**UNITED STATES OF AMERICA  
NUCLEAR REGULATORY COMMISSION**

In the Matter of	)	
	)	
Duke Energy Florida, LLC	)	Docket Nos. 52-029 and 52-030
	)	
(Levy Nuclear Plant, Units 1 and 2)	)

**DUKE ENERGY FLORIDA’S RESPONSES TO PRE-HEARING QUESTIONS**

Downspout Screen Location

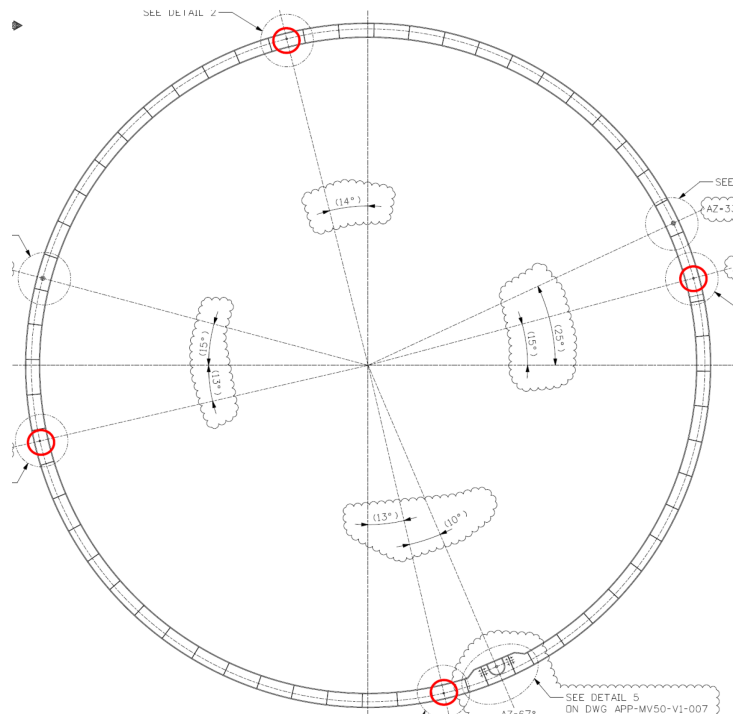
**Question 25.** As a part of LNP DEP 3.2-1 and LNP DEP 6.3-1, the applicant describes the addition of protective screens to the downspouts to protect the passive residual heat removal heat exchanger (PRHR HX) from debris. Has the applicant or the Staff investigated whether the screens could be subject to clogging phenomena similar to what is considered by Generic Safety Issue 191 (GSI-191)? Has the applicant performed any analysis to determine how long the PRHR HX can remain functional with degraded return flow to the in-containment refueling water storage tank (IRWST)?

When designing the downspout system and screens which interface with the polar crane girder (PCG) and the internal stiffener, plugging of one of the downspout screens was taken into

consideration to meet single failure criteria. Design calculations support downspout sizing and screen sizing considering a single failure (plugging of a downspout screen), and flowrates are shown to support adequate pressure drop to avoid overflowing at any one location while avoiding the potential for flashing in the system piping.

Related to their location in containment, the polar crane girder and internal stiffener are not easily accessible and are not located in high traffic areas which may result in potential cleanliness issues that may plug any of the screens. The four screens added at the polar crane girder and internal stiffener are evenly spaced around containment to provide separation between each of the downspout connections. The figure below provides detail as to the location of the screens at the internal stiffener elevation.

Figure: Polar Crane Rail and Dam

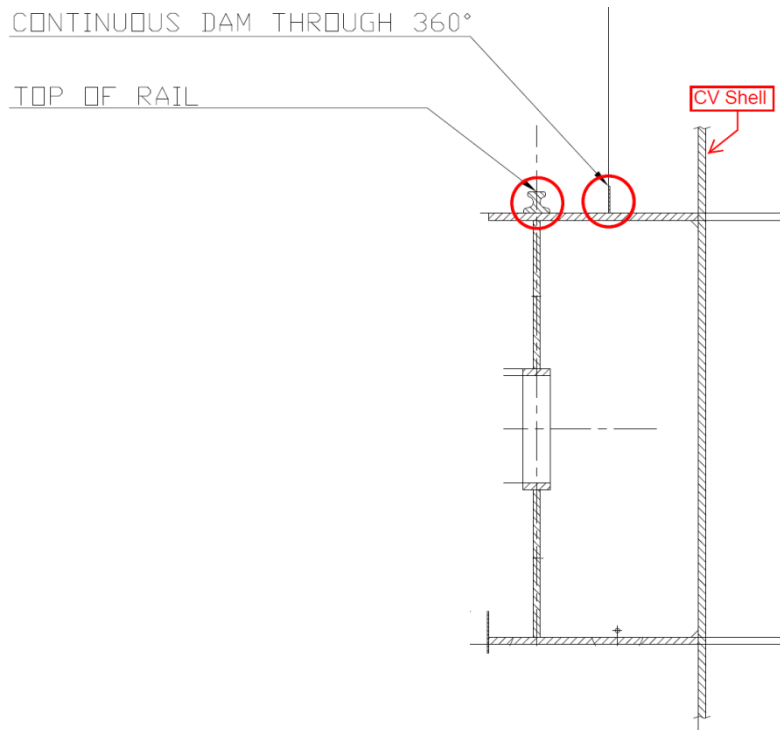
**Question 27.** As part of the exemption for DEP 3.2-1 related to the passive core cooling system (PXS) containment condensate return, Technical Specification (TS) Surveillance Requirement 3.5.4.7 was added to require a visual inspection of the IRWST gutter and downspout screens to verify that the return flow to the IRWST will not be restricted by debris.

The Staff's technical evaluation of the exemption request and departure states, "Condensate return is one of the primary factors influencing the performance of the PRHR HX." The Staff further explains that the PXS downspout piping network was added at the polar crane girder and stiffener with four specific collection points located on both the upper portion and the

The position of the polar crane on the girder has no impact to the rate of condensate return. The rail that the polar crane rides on is located several feet from the containment vessel shell, and goes around the entire circumference of containment. The dam which was added on the polar crane girder is located between the containment vessel shell and the polar crane girder rail. Therefore, any condensation which occurs on the containment vessel shell and travels down the shell to the polar crane girder collection location will be separated by the dam from any interaction with the polar crane itself. Any condensation which occurs on the polar crane and/or the polar crane structure that spans from one side of containment to the other will not be captured by the gutter system. This is accurately modelled in WGOTHIC as a heat sink, and therefore no credit is taken for capturing this lost condensation. The Figure below shows an image of the continuous dam and also the rail for the polar crane.

In the Figure above, the polar crane rail and the continuous dam are circled. The containment vessel shell is pictured at the right of the figure. Therefore, based on the orientation of the polar crane circumferential dam, there is no need for a Technical Specification or Surveillance Requirement restricting the polar crane bridge position on the girder.
